Access Compliance Report

Public Rights-of-Way

Intersection ID: 48393	Main Street: SHUFFLETOWN_DR	Cross Street: JOE_MORRISON_LN	Location: E
ADA ID: DB74D64A9926	Ramp Type: PerpDiag	Initial Pass/Fail: Fail	Overall Compliance: No
Severity Score: 21.25			
Codes/Mitigation Info/Possible Solution		Field Measurements/Component Compliance

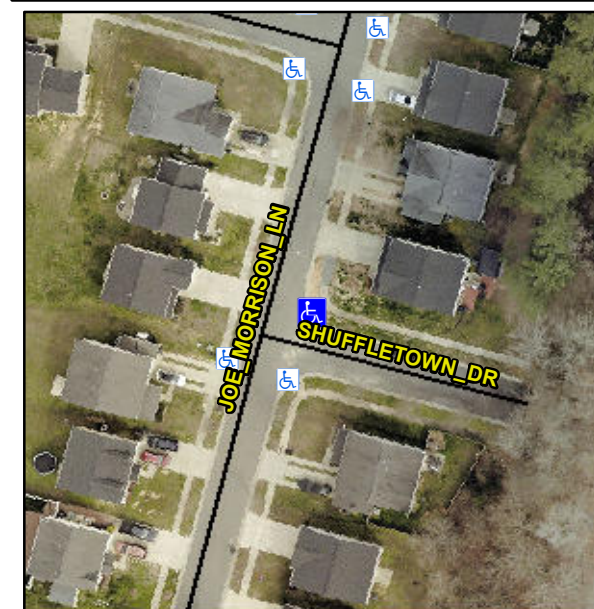
Not Found, R304.5.1, R304.2.2

Compliance	Description	Data	Compliance	Description	Data
N/A	Ramp Length (in)	73.0	No	Ramp Slope (%)	11.1
No	Ramp Width (in)	45.0	Yes	Ramp XSlope (%)	1.1
N/A	Flare Type LT	N/A	N/A	Flare Type RT	N/A
N/A	Flare Slope LT (%)	N/A	N/A	Flare Slope RT (%)	N/A
N/A	Flare Traversable LT?	N/A	N/A	Flare Traversable RT?	N/A
N/A	Landing Length (in)	N/A	N/A	DWS Provided?	N/A
N/A	Landing Width (in)	N/A	N/A	DWS Contrast?	N/A
N/A	Landing Slope (%)	N/A	N/A	DWS Length (in)	N/A
N/A	Landing X Slope (%)	N/A	N/A	DWS Full Width?	N/A
N/A	Landing Curb? (Y/N)	N/A	N/A	DWS Offset (in)	N/A
N/A	Shared Landing?	N/A			
N/A	Gutter Ponding?	N/A	N/A	Gutter Slope (%)	N/A
N/A	Gutter Lip Ht (in)	N/A	N/A	Gutter X Slope (%)	N/A
N/A	Painted X Walk1?	No	N/A	Painted X Walk2?	No
	X Walk 1 Direction	To NW		X Walk 2 Direction	To S
N/A	X Walk 1 Width (in)	N/A	N/A	X Walk 2 Width (in)	N/A
	X Walk 1 Slope (%)	2.4		X Walk 2 Slope (%)	1.5
	X Walk 1 X Slope (%)	2.4		X Walk 2 X Slope (%)	0.2

Remove & Replace Curb Ramp With Two New Directional Ramps or Equivalent.
